Docket Item # 15
BAR CASE # 2008-0116

BAR Meeting
July 30, 2008

ISSUE: Waiver of Rooftop HVAC Screening

LOCATION: 532 N. Washington Street

Figure 1. Proposed roof plan.

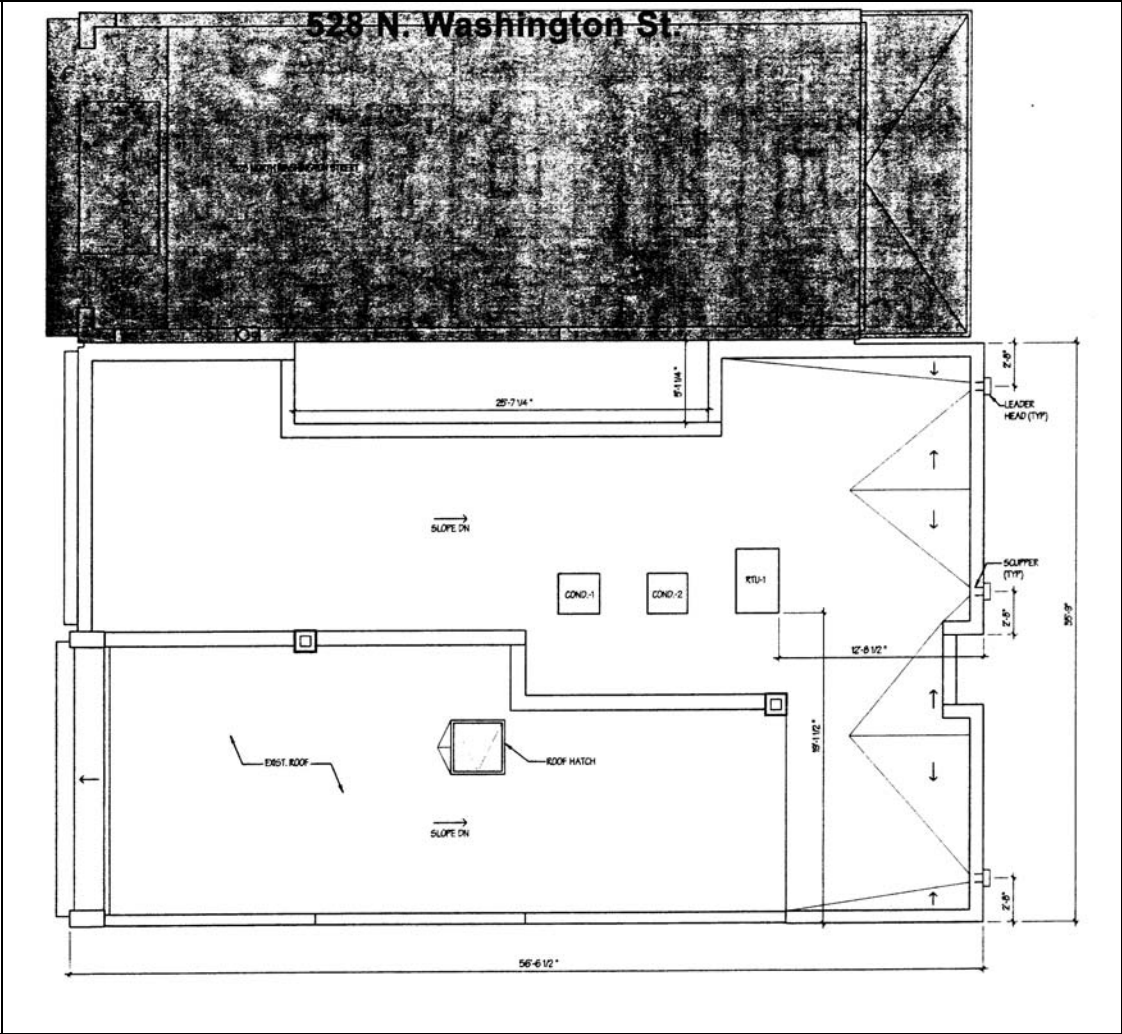
The applicant is requesting a Waiver of Rooftop HVAC Screening Requirement for 532 North Washington Street. The HVAC equipment is proposed to be located on the proposed addition at 532 North Washington Street. The proposed roof plan indicates the placement of three HVAC units on the middle portion of the addition.

Figure 2. Sight line of HVAC equipment across Pendleton Street.

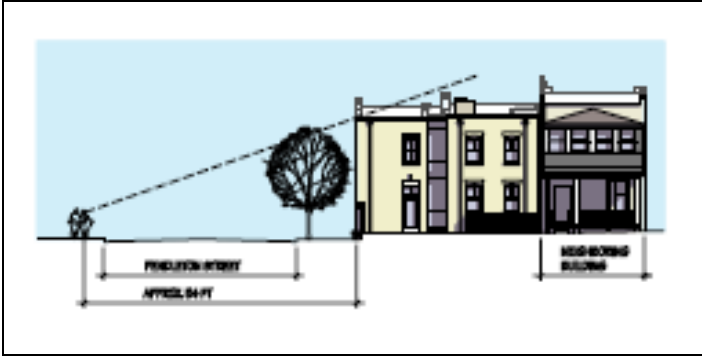
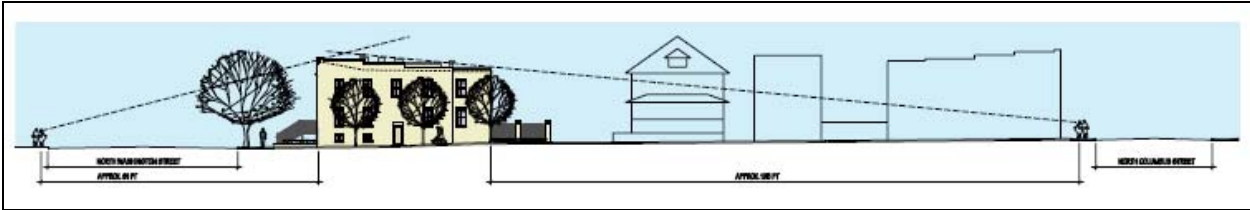
When considering the request for a Waiver of Rooftop HVAC Screening Requirement, one must consider the visibility of the HVAC equipment and/or screening from the public right-of-way. The *Design Guidelines* advise that “HVAC equipment should be located in a visually inconspicuous area of a building” and that “HVAC equipment should not disrupt the architectural character of a structure.” Staff finds that the proposed placement of the rooftop HVAC units will be minimally visible from the public right-of-way. The applicant has submitted sight lines that illustrate the minimal visibility of the proposed rooftop equipment. Staff recommends painting the equipment in a color that will further allow the equipment to recede. Staff has no objections to the proposed Waiver of Rooftop Screening Requirement should the Board approve the Certificate of Appropriateness for the addition.

Staff recommends approval for a Waiver of Rooftop HVAC Screening Requirement provided that a Certificate of Appropriateness is approved by the Board for the addition.
